WYONG SHIRE COUNCIL

**Wyong Temporary Desalination Plant - Tuggerah Beach**

<b>Applicant:</b>	Wyong Shire Council
<b>Owner</b>	Crown Land (NSW Department of Lands)
<b>Application No</b>	1668/06
<b>Description of Land</b>	Lot 623 DP 822104
<b>Proposed Development</b>	Temporary Desalination Plant
<b>Site Area</b>	Compound area 800m <sup>2</sup>
<b>Zoning</b>	7(a) Conservation Zone
<b>Existing Use</b>	Coastal reserve adjacent to beach car park

This Planning Report has been prepared by Maunsell Australia Pty Ltd on behalf of Wyong Shire Council to independently assess the development application for the proposed **Tuggerah Beach Temporary Desalination Plant**. This assessment has been prepared in accordance with Part 4 of the *Environmental Planning and Assessment Act 1979* (EP&A Act).

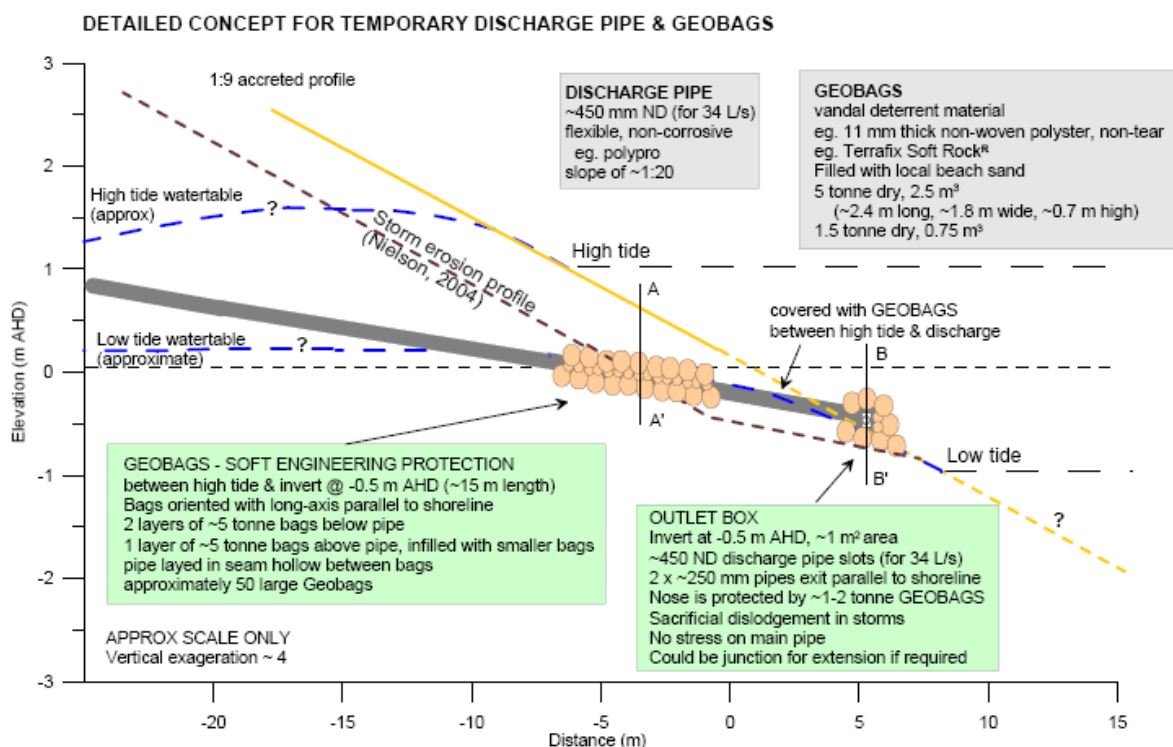
*“The bores and brine dissipater will be located between the high and low tide levels, however a portion of the sand filled geobags surrounding the outlet pipe will be visible above the high tide level”*

Establishing a seawater outfall above the beach profile will generate a negative impact on the visual landscape by interrupting what is now a continuous beach foreshore. However, due to the temporary nature of the proposal and the community benefit from augmenting water supplies, the detrimental impact generated by the proposed outfall infrastructure is considered reasonable. This assumes that the seawater discharge infrastructure is to be completely removed upon cessation of operations.

In extreme storm events, there is potential for the seawater outfall infrastructure to be further exposed. Reference is made to Figure 4.1 (reproduced below) of the design report (UNSW Water Research Laboratory, 2006), which demonstrates the extent to which the geobags may be exposed if a severe storm causes significant erosion.

**TYPICAL BEACH WELL PIPEWORK DETAILS**

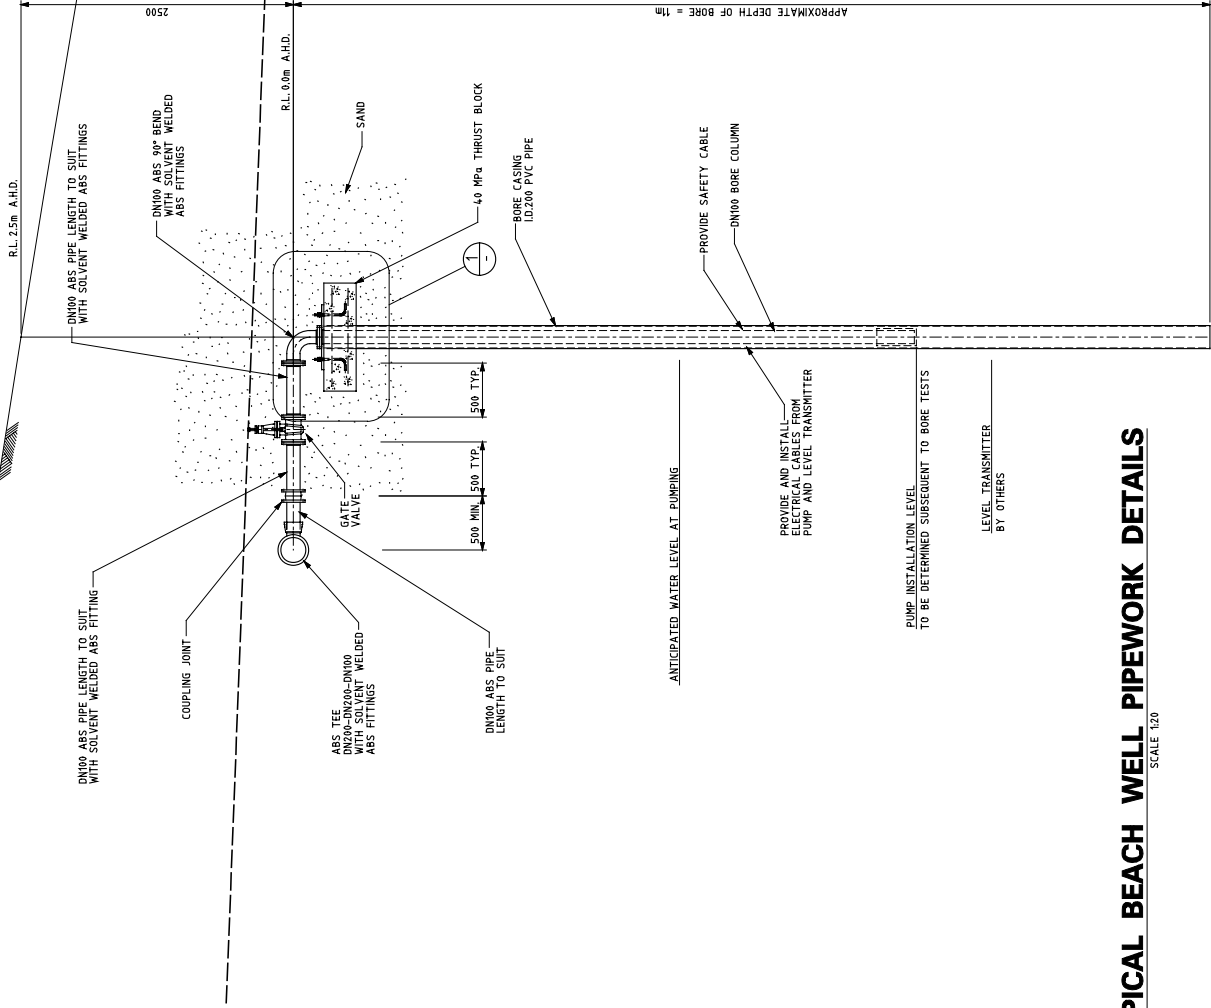
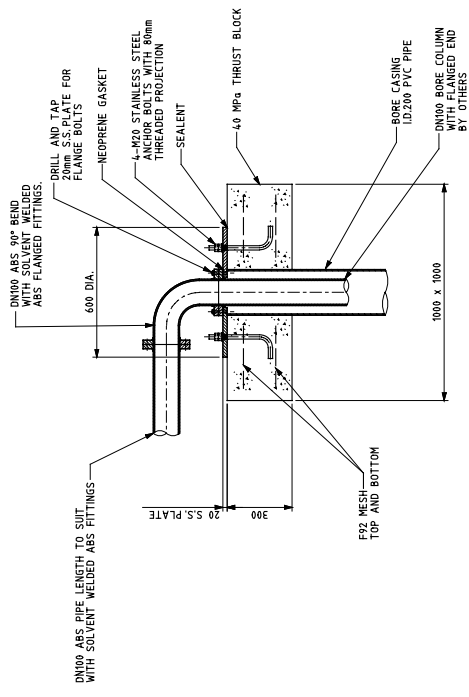
Reference to Figure 4.2 of the same report (reproduced below) shows an outfall structure height of around 0.5 m. In reality, if Terrafix Soft Rock products are used (0.75 m<sup>3</sup> bags are 400 mm high, 2.5 m<sup>3</sup> bags are 650 mm high) an overall structure height of around 2.3 m could be expected. After a significant erosion event, this structure would represent a significant physical and visual barrier on the beach. The 5T bags (using Terrafix “Soft Rock” dimensions are 1.8 m \* 2.4 m \* 0.65 m high – around 2.5 m<sup>3</sup>, accounting for curvature on edges).
